**CONCEPTUAL, BASIC and DETAIL DESIGN
ENGINEERING OF STYRENE PARK OFFSITE**

Document Title: P&ID for Basket Filter

Document No. : EI027-ENR-VD-PR-PID-003

Rev.: R2

INSTRUMENT CODES

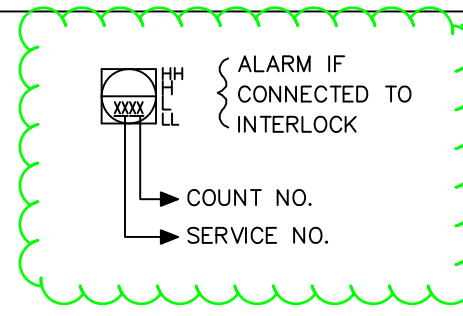
This coding has discrepancy with the instrument tags in P&ID section
Noted

PK-0001-A

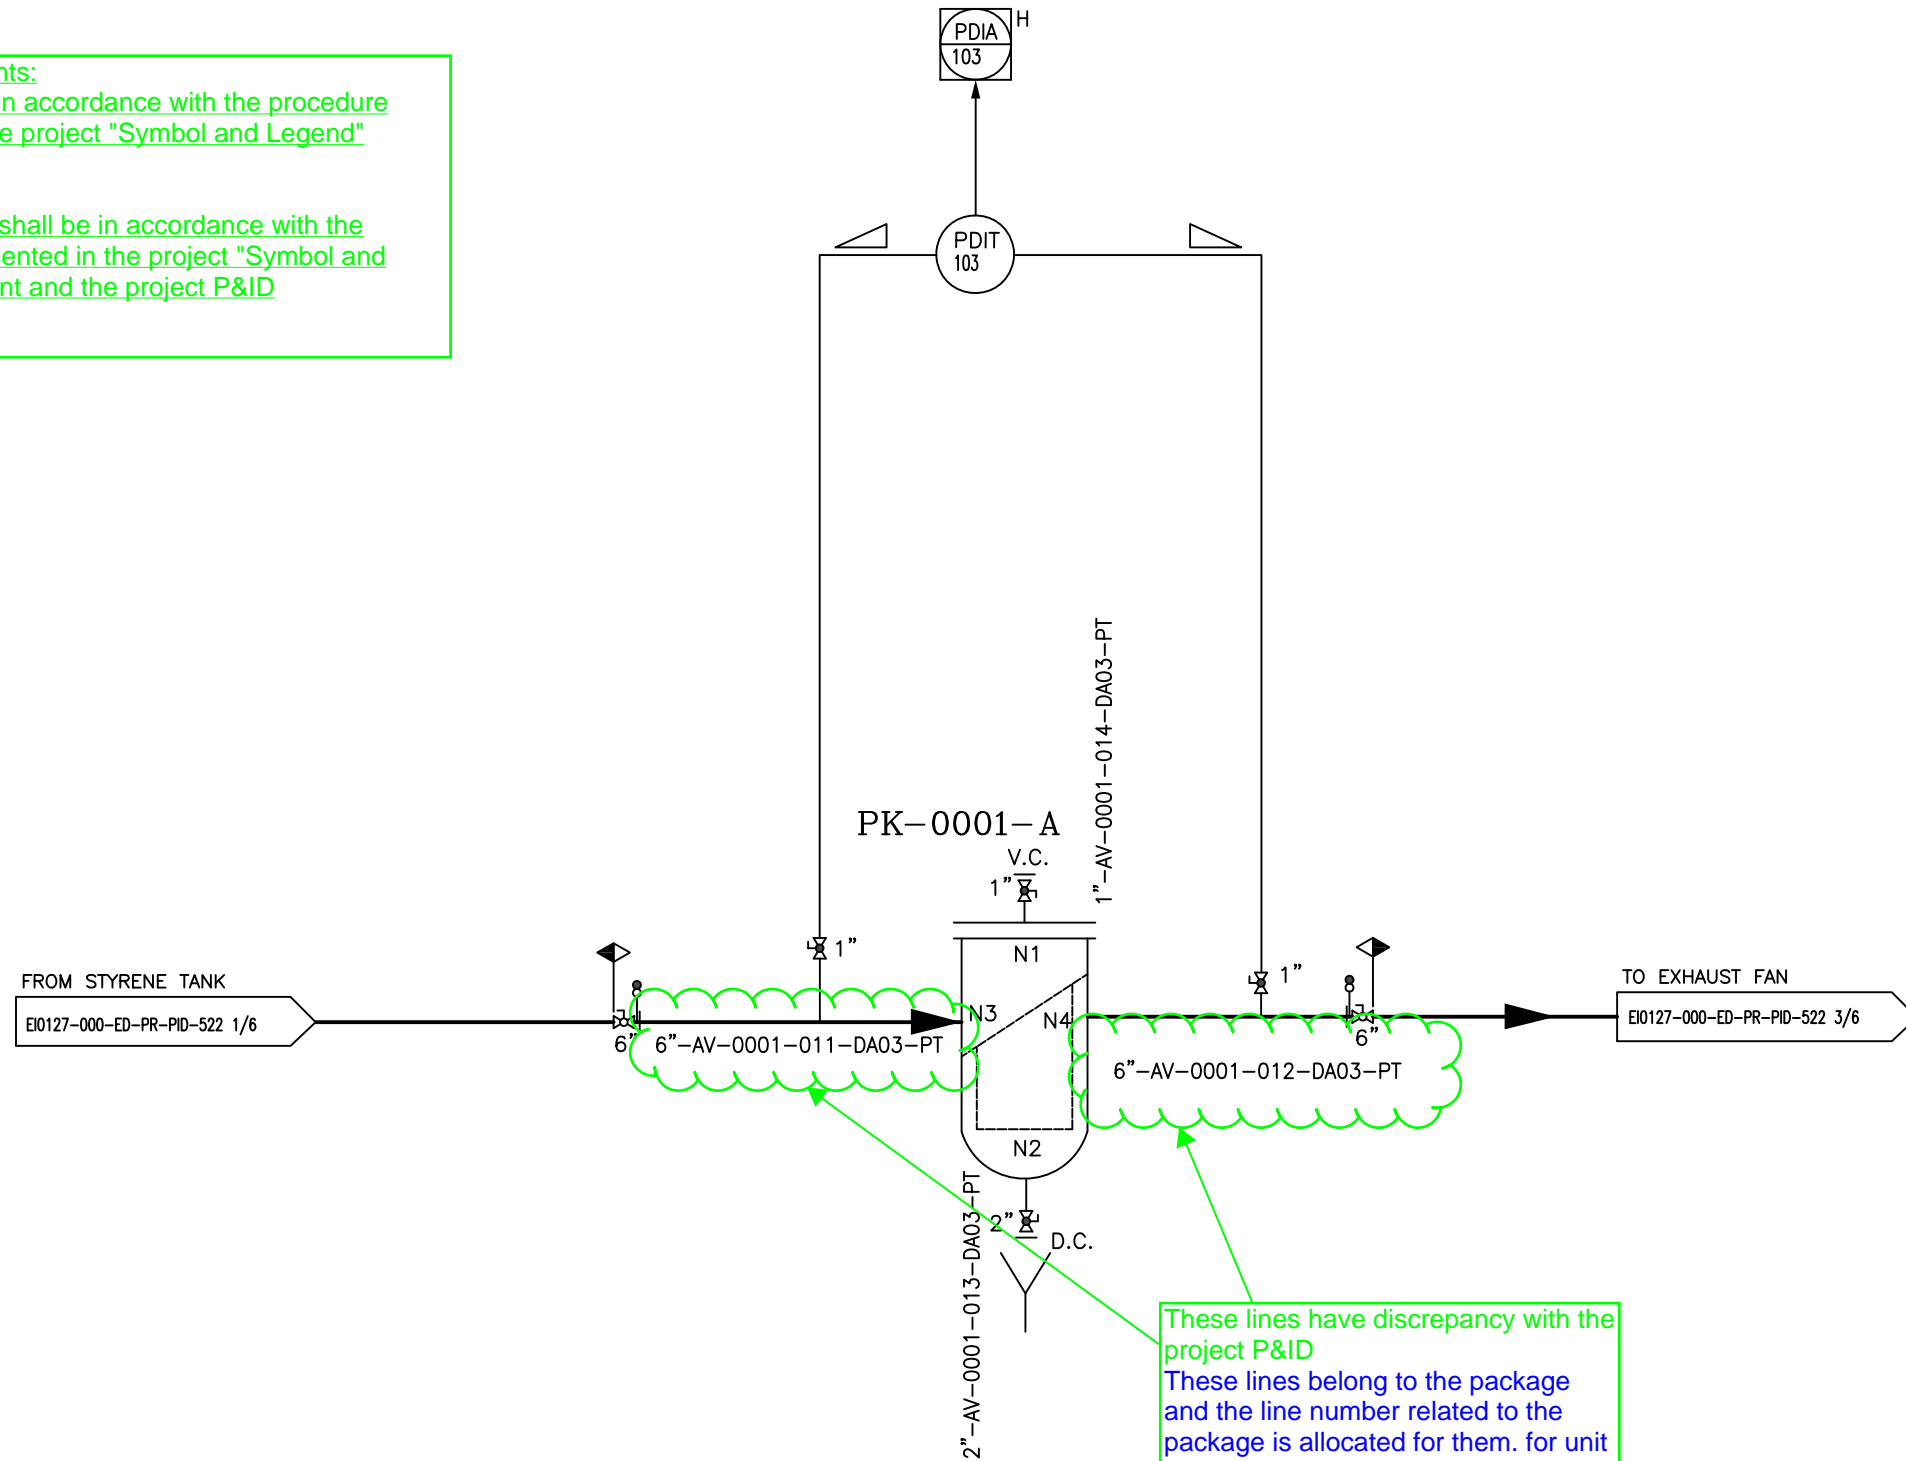
1- Tags shall be in accordance with the procedure represented in the project "Symbol and Legend" document

2- Line numbers shall be in accordance with the procedure represented in the project "Symbol and Legend" document and the project P&ID

These lines have discrepancy with the project P&ID
 These lines belong to the package and the line number related to the package is allocated for them. for unit number "01" has been allocated.

Noted

Noted

PK-0001-B
AIR AFTER FILTER

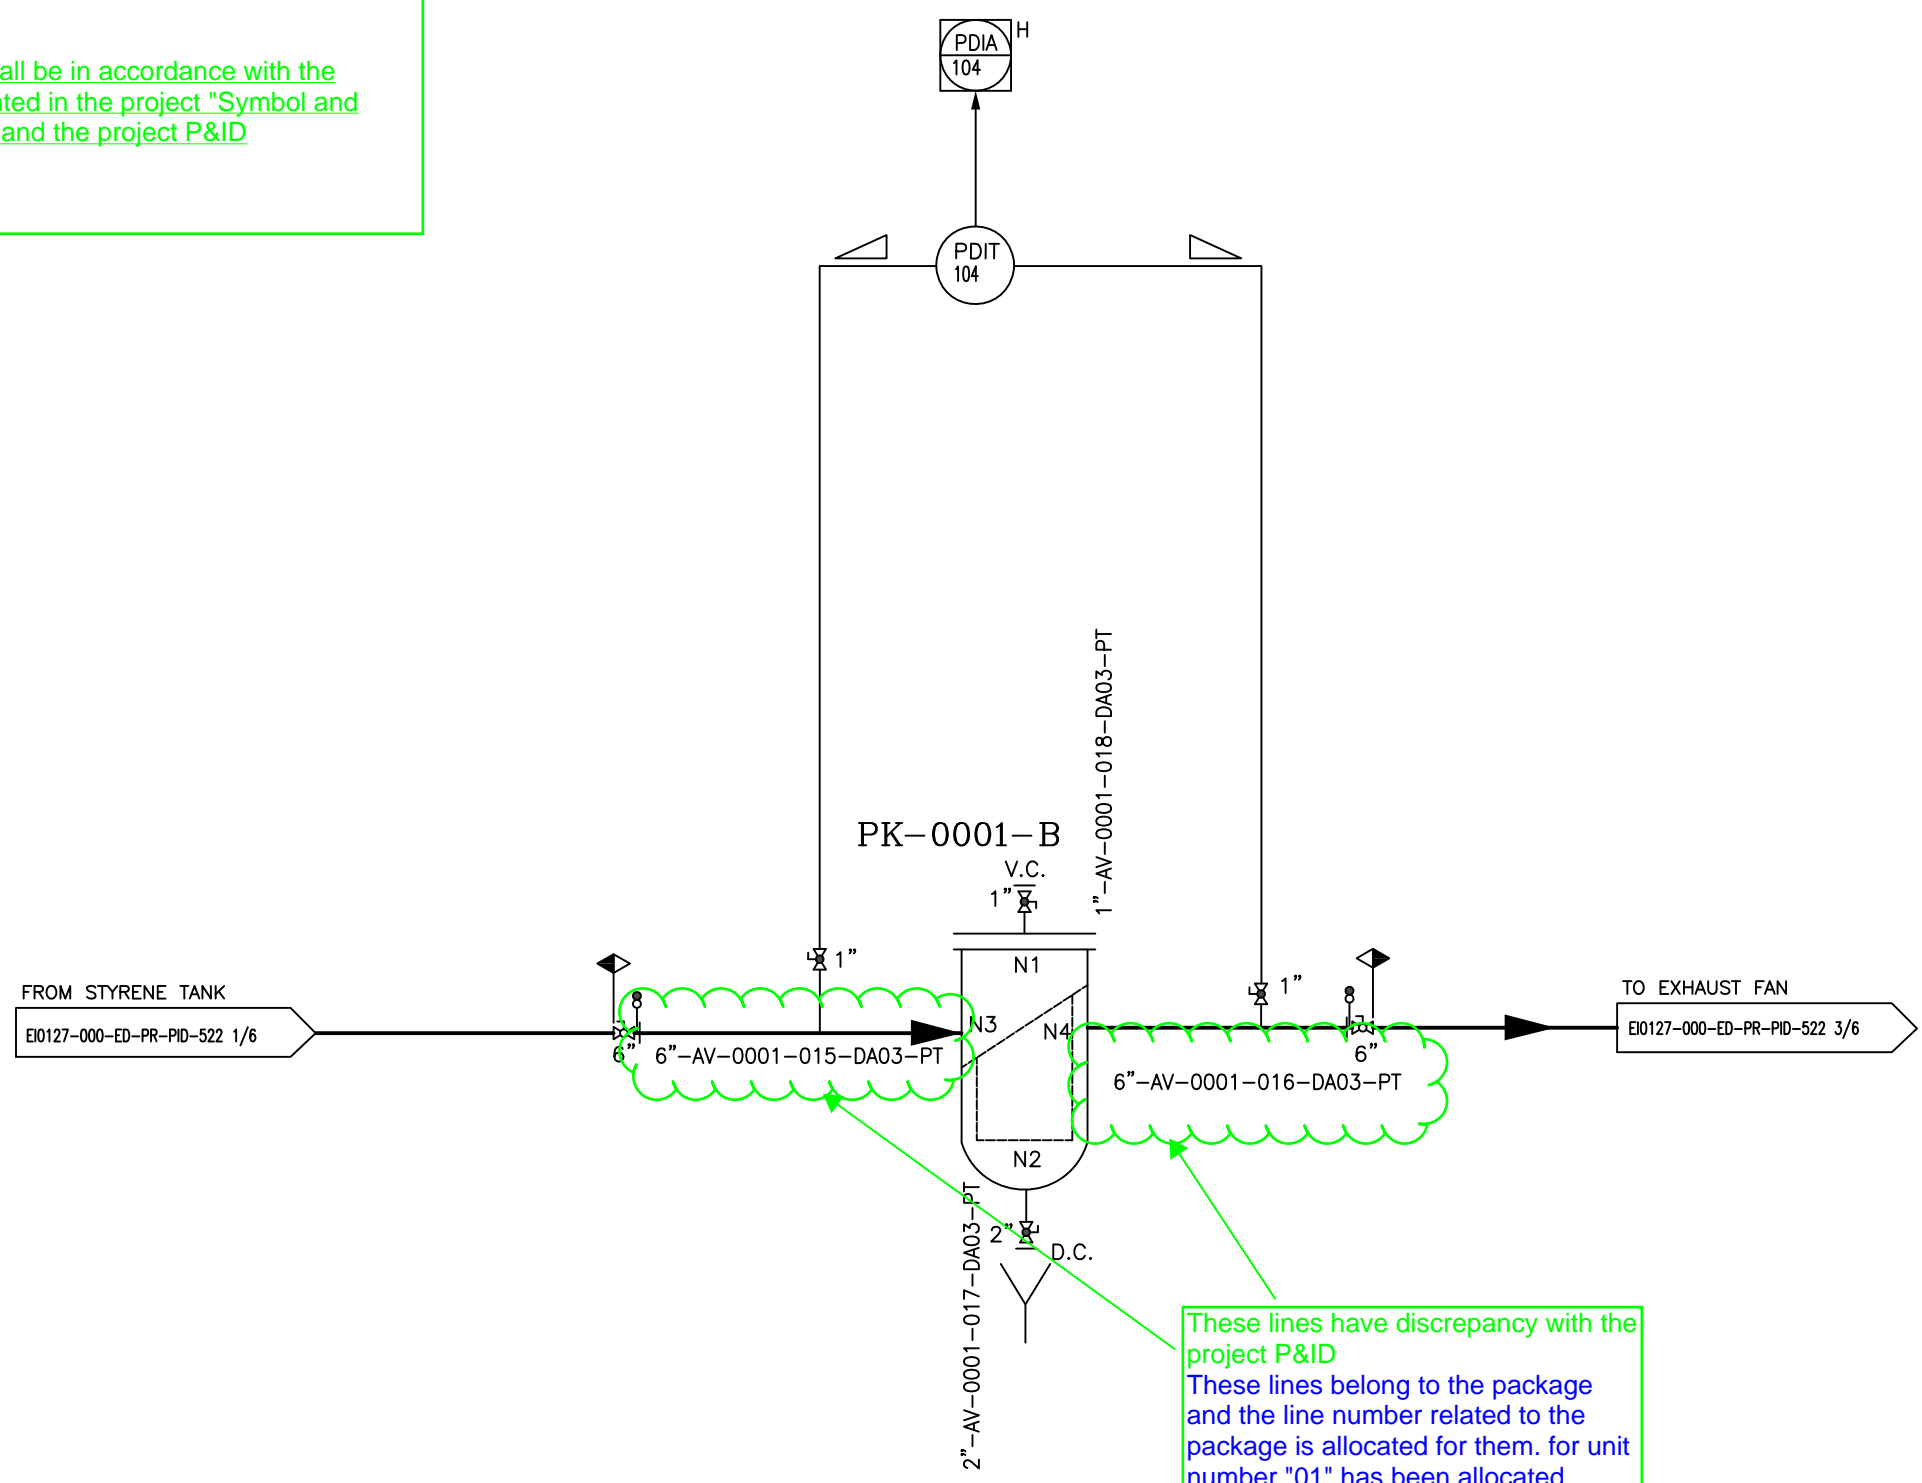
General Comments:
 1- Tags shall be in accordance with the procedure represented in the project "Symbol and Legend" document
 Noted
 2- Line numbers shall be in accordance with the procedure represented in the project "Symbol and Legend" document and the project P&ID
 Noted

These lines have discrepancy with the project P&ID
 These lines belong to the package and the line number related to the package is allocated for them. for unit number "01" has been allocated.
